URBAN PLANNING DELEGATED COMMITTEE AGENDA

3.1 1 Creswick Street, Hawthorn (Construction of an additional dwelling on a lot) - PP21/0139

PLANNING ASSESSMENT Urban Planning Delegated Committee

Application Number	PP21/0139
Date Application Received	23/02/2021
60 Day Statutory Time Frame	12 April 2024
Planning Officer	Timothy Luckin

Figure 8 - Proposed landscaping

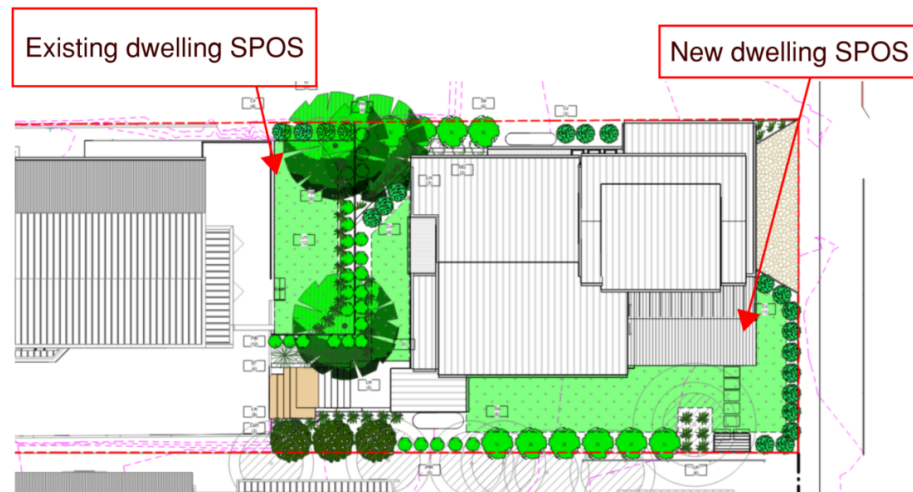
Both the new and existing dwelling have SPOS areas which have a minimum dimension exceeding 3m. A screenshot of the landscape plan is shown in Figure 8 below and

demonstrates there will be large areas provided for new planting including trees. Conditions will require a new small tree to be planted in each secluded private open space.

- c. One (1) small tree (minimum 2 metres tall when planted and must achieve a minimum mature height of 7 metres and canopy spread of 5 metres) in the secluded private open space of the new rear dwelling;

- d. Each small tree must be provided a minimum of 12 sqm of deep soil, with the available soil area clearly shown on the landscape plan;
 - e. All trees must comply with Australian Standard AS2303:2015 - Tree Stock for Landscape Use;

Tree 10 viewed from laneway

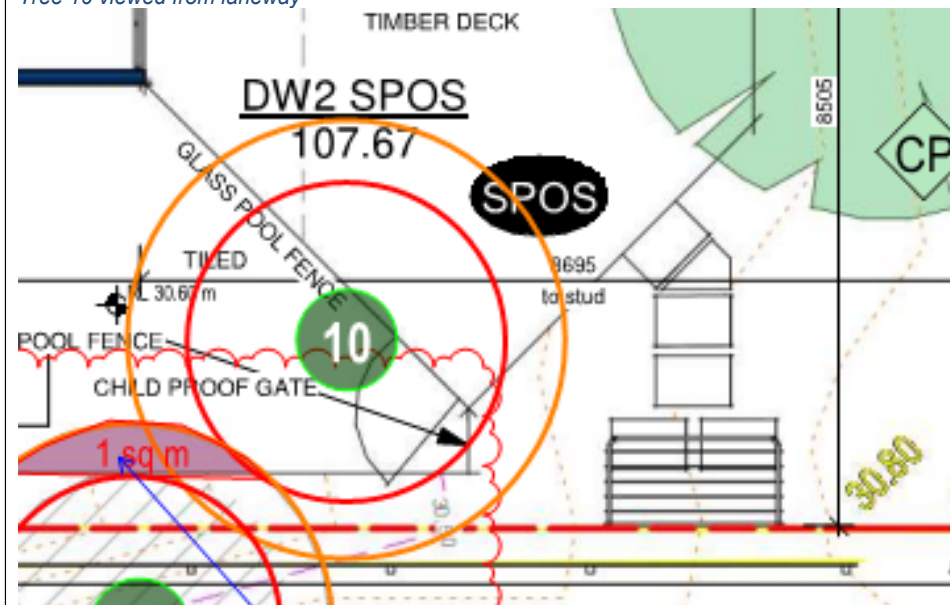
Note: following submission of the S57A plans, this requirement has been satisfied. The only change needed is to move the clothesline out of the TPZ of Tree 10.

This tree has been identified in the arborist report as being of low retention value due to its health, structure and issues with wood borers. The tree is of relatively low amenity and retention value with borer damage observed within the main trunk and branch attachment. The removal of this tree does not require a local law permit. The tree could be retained with the deletion of parts of the deck and reconfiguration of the pool fence, but given its condition, size and potential impacts to property in the future, its removal with more suitably located replacement planting is considered a good outcome.

- a) Proposed clothesline and associated pavement to be located outside of Tree 10's Tree Protection Zone.
- b) The Tree Protection Zone and Structural Root Zone of Tree Nos. 10, 12, 13, 14, 15, 17 and 18 (as identified in the Arborist Report submitted with the application prepared by Joe Kellett Arboriculture (dated 28/04/2021) drawn on all site and floor plans;
- c) Notation on all site and floor plans that Tree Nos. 10, 12, 13, 14, 15, 17 and 18 are to be retained and protected in accordance with the endorsed Tree Management Plan required by this Permit;
- d) Any modifications to the location or layout of buildings and/or works recommended in the endorsed Tree Management Plan required by this Permit;

1 LANDSCAPE PLAN
TP 5.0 1 : 100

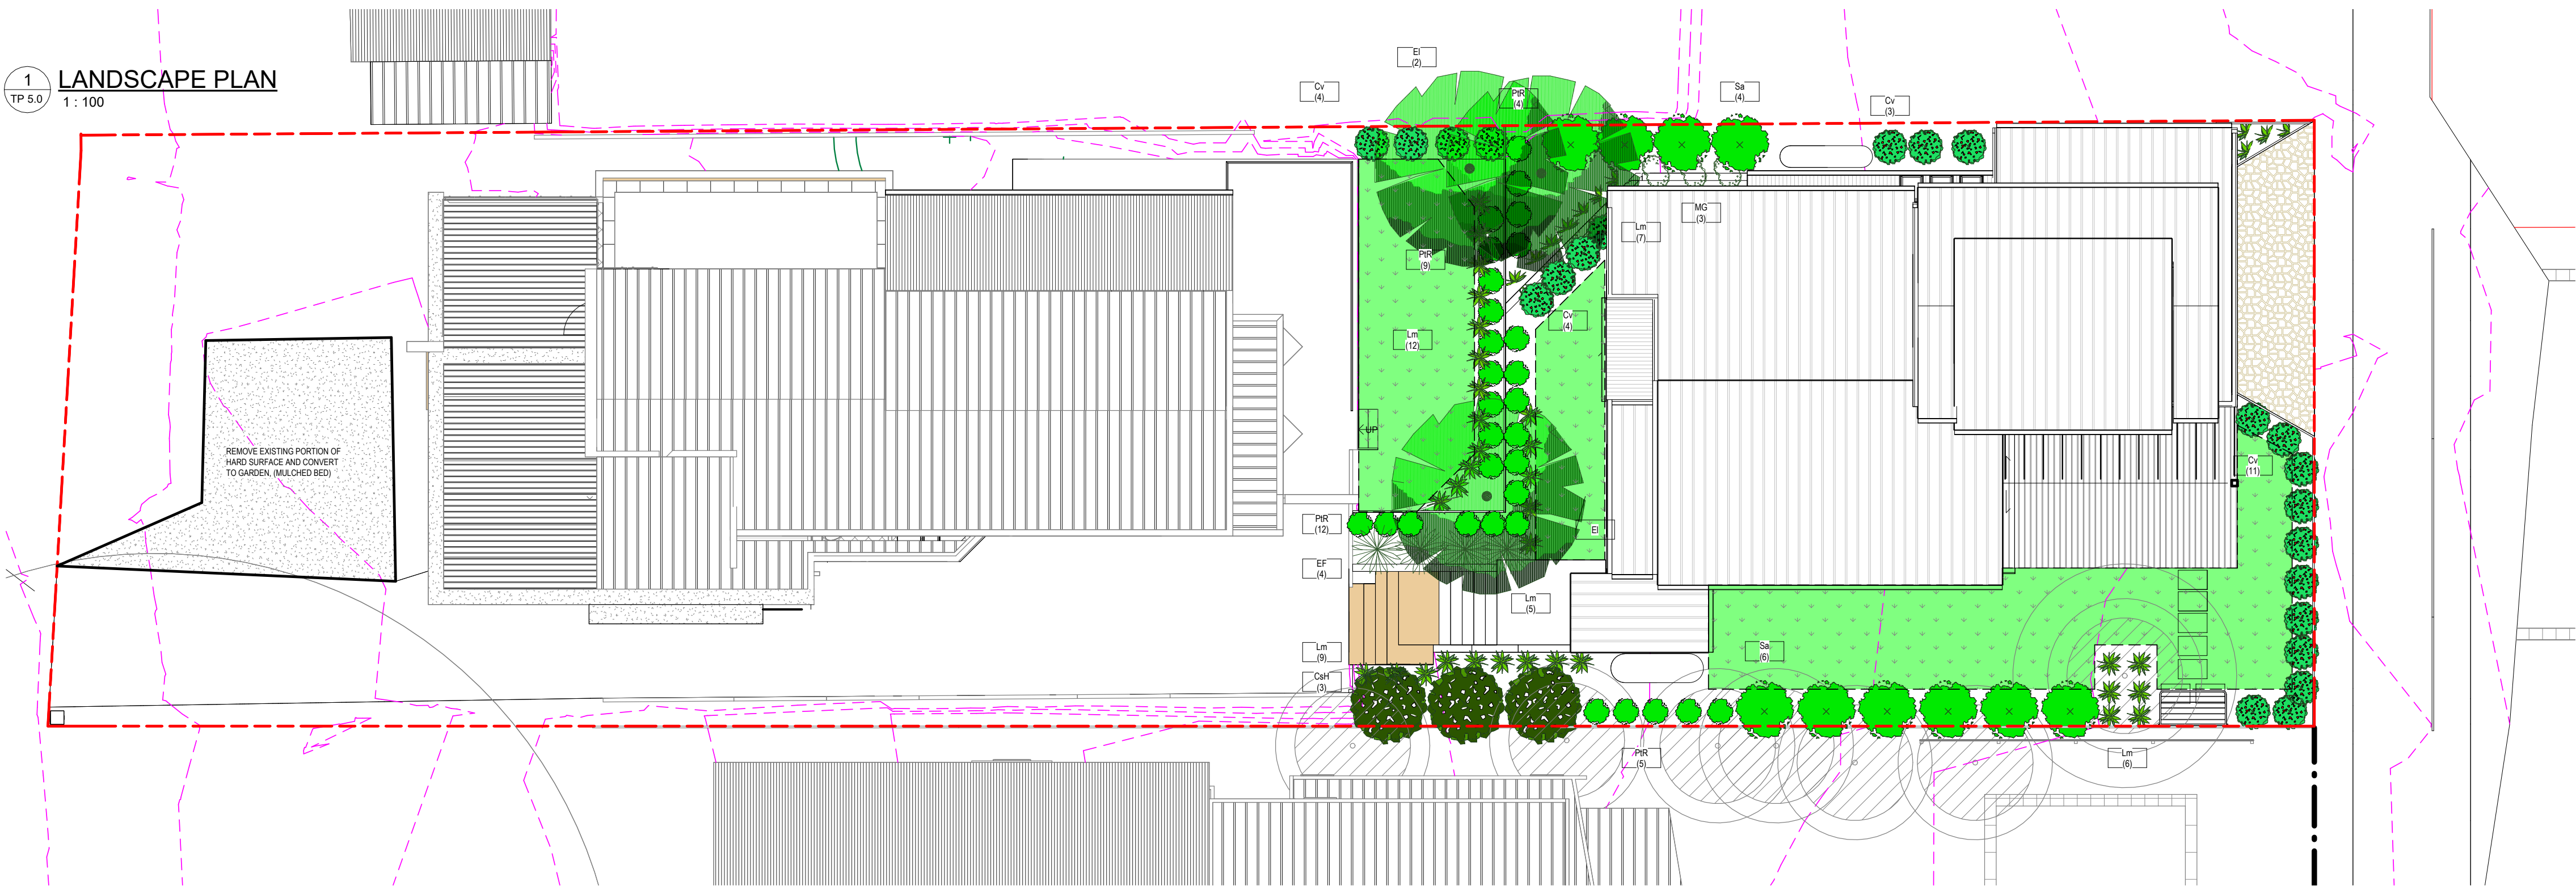
- g. All drainage plans must show proposed trees to be planted in accordance with the landscape plan submitted with the application.

4. A landscape plan to the satisfaction of the responsible authority must be submitted to and approved by the Responsible Authority. The plan must be drawn to scale with dimensions and electronic copies provided (unlocked PDF). When endorsed, the plan will form part of the permit. The landscape plan must show:

- a. A survey (including botanical names) of all existing trees to be retained and of those to be removed. The intended status of the trees shown on the landscape plan must be consistent with that depicted on the development layout plan;

- b. One (1) small tree (minimum 2 metres tall when planted and must achieve a minimum mature height of 7 metres and canopy spread of 5 metres) in the rear secluded private open space of the front dwelling;

- f. All small trees must be planted by an AQF Level 3 Qualified Arborist, Landscape Gardener or Horticulturist;
 - g. All small trees must be planted more than 1 metres away from any structures, paving, decking, property boundaries, easements, existing trees or shrubs.
